PCN #: 2153

PCN Title: Qualification of Additional Assembly Sites and Package Outline Dimension Changes

PCN-2153 REV 1

Figure 2: New Configuration for TO220AB (Option A is baseline and Eris, Option B is HTME)

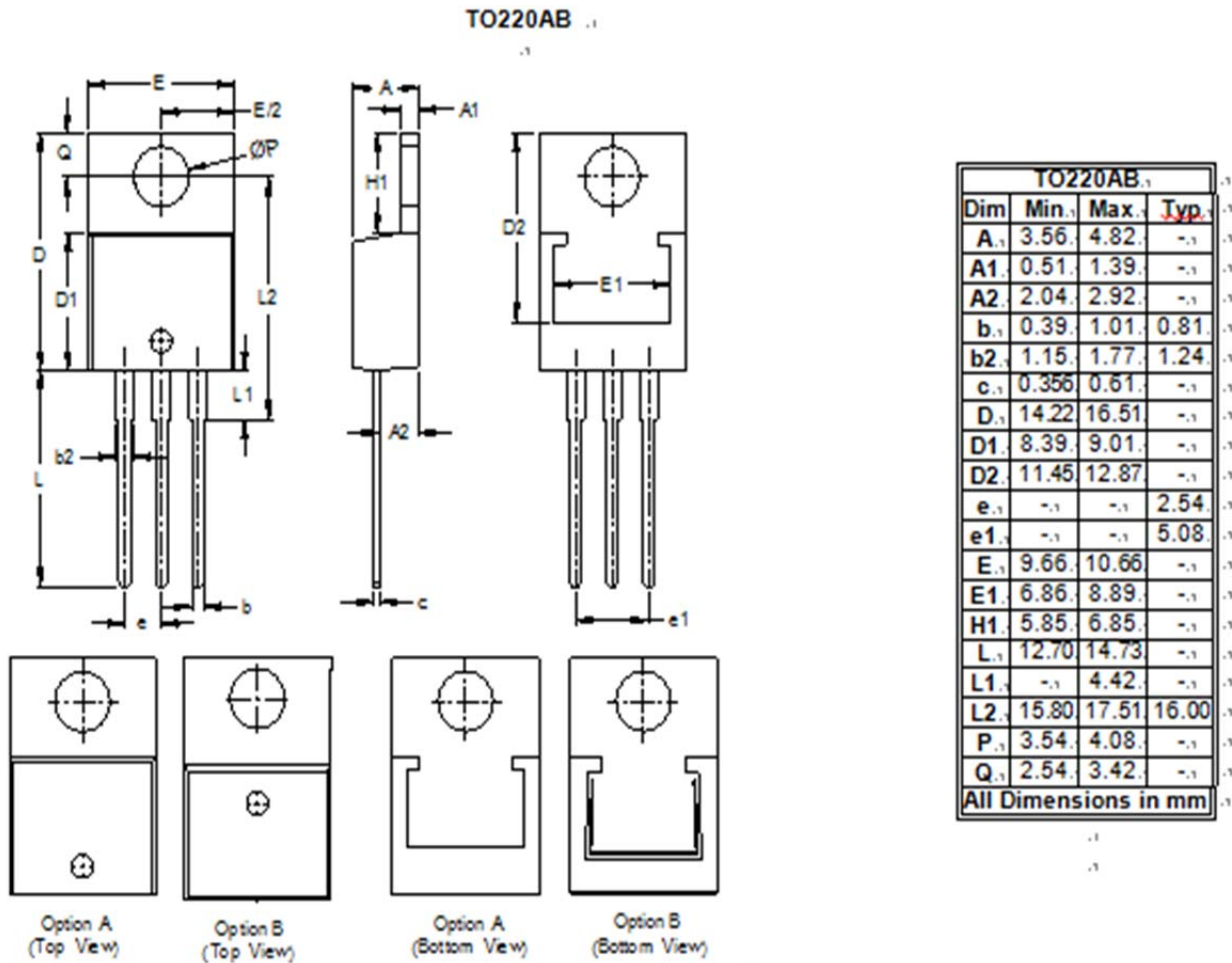
IMPACT				
<p>Figure 1: Current Configuration of TO220AB Figure 2: New Configuration for TO220AB (Option A is baseline and Eris, Option B is HTME) Note: The new POD's dimensions are the same as the baseline.</p> <p>Figure 3: Current Configuration of TO252 Figure 4: New Configuration of TO252 (Option A is baseline and Option B is HTME) Note: The L4 dimension has changed from min 0.64mm to min 0.60mm</p> <p>Figure 5: Current Configuration of TO263 Figure 6: New Configuration of TO263AB (Option A is baseline and Option B is HTME) Note: The new POD's dimensions are the same as the baseline.</p>				
PRODUCTS AFFECTED				
Table 1: Additional Assembly and Test Site, Tianshui Huatian Electronic Group in Tianshui, China (HTME) Table 2: Additional Assembly and Test Site, Eris Technology Corp in New Taipei, Taiwan (ERIS) Table 3: Additional Assembly and Test Sites, HTME and ERIS				
WEB LINKS				
Manufacturer's Notice:	https://www.diodes.com/quality/product-change-notices/diodes-product-change-notices/
